Amendment under 37 C.F.R. § 1.111  
Appln. No. 10/715,089

**IN THE DRAWINGS**

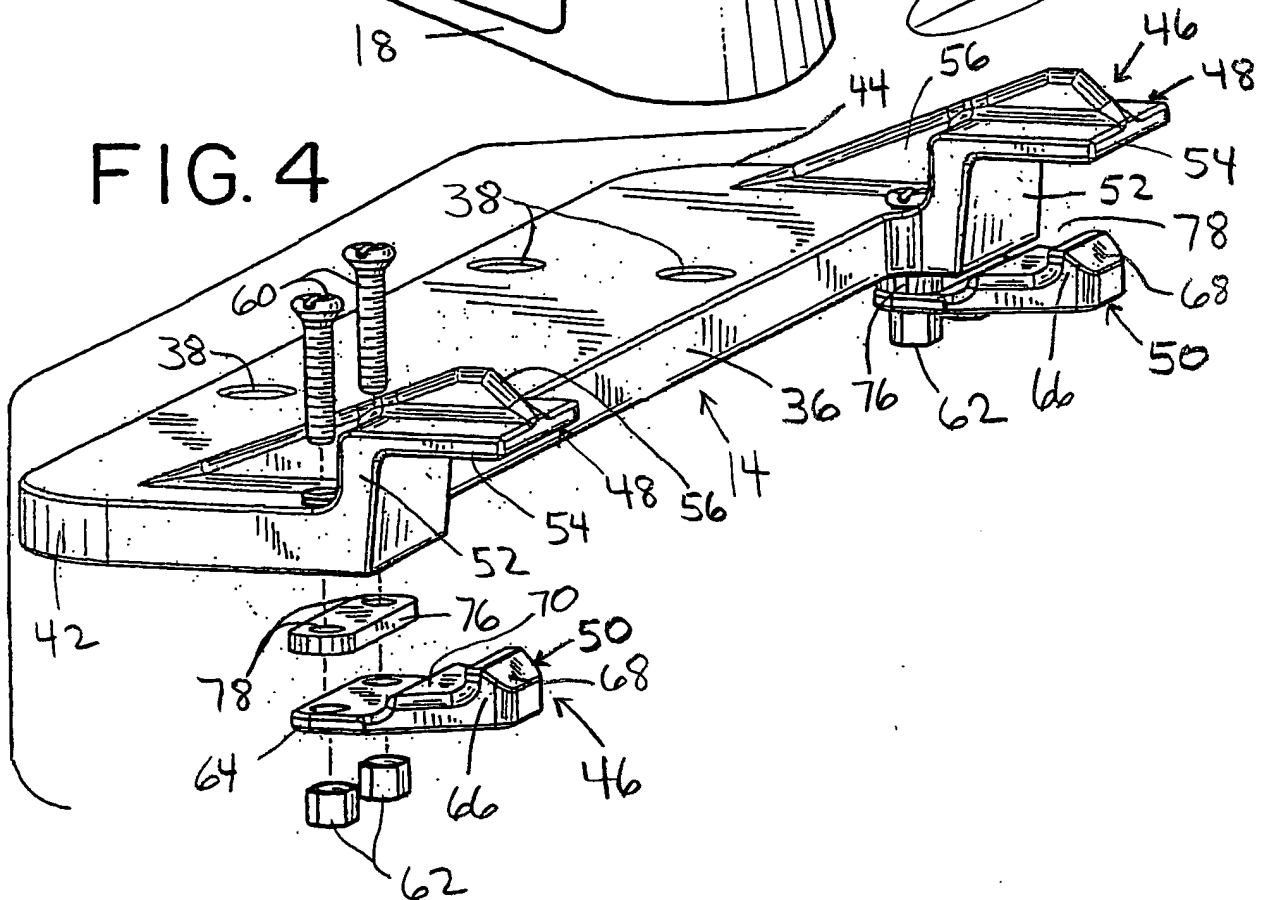
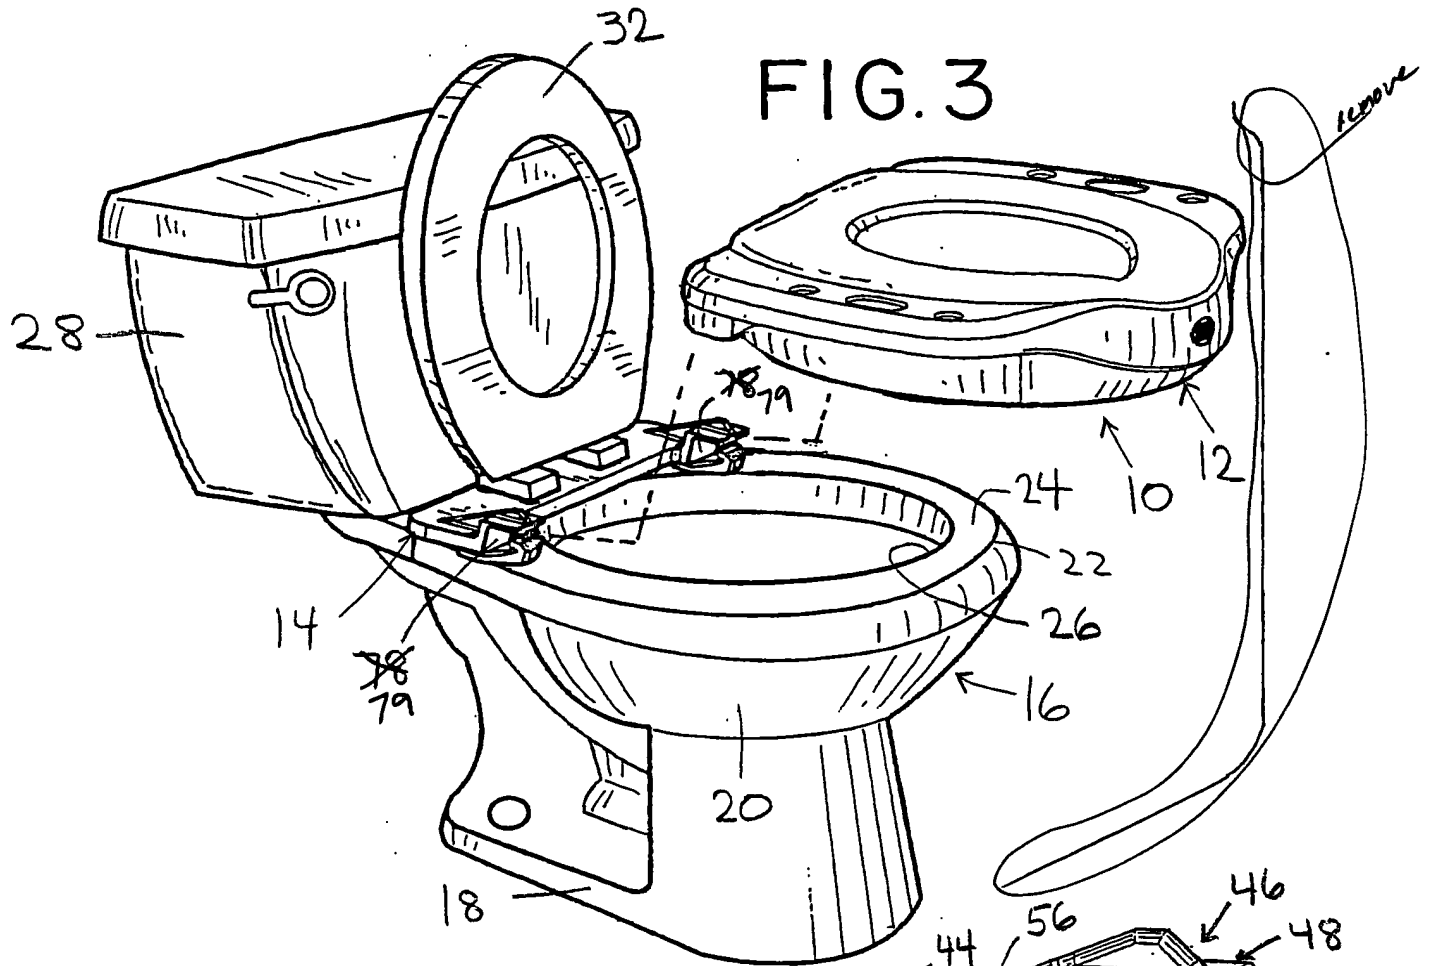
The drawings stand objected to under 37 C.F.R. § 1.84. Applicant submits herewith a set of formal drawings in which corrections were made to the initially filed drawings. As suggested by the Examiner, the angled line bordering Figs. 3 and 4 has been removed. Furthermore, Figs. 3/4 and the specification have been amended to refer to reference number 79 as the receiving socket and to continue to refer to reference number 78 as holes. Accordingly, Applicant requests that the objection to the drawings be reconsidered and withdrawn.

Applicant submits formal drawings marked as “Replacement Sheets” having the corrections requested by the Examiner. Additionally, Applicant submits annotated drawings marked as “Annotated Marked-up Drawings” which show the changes made.
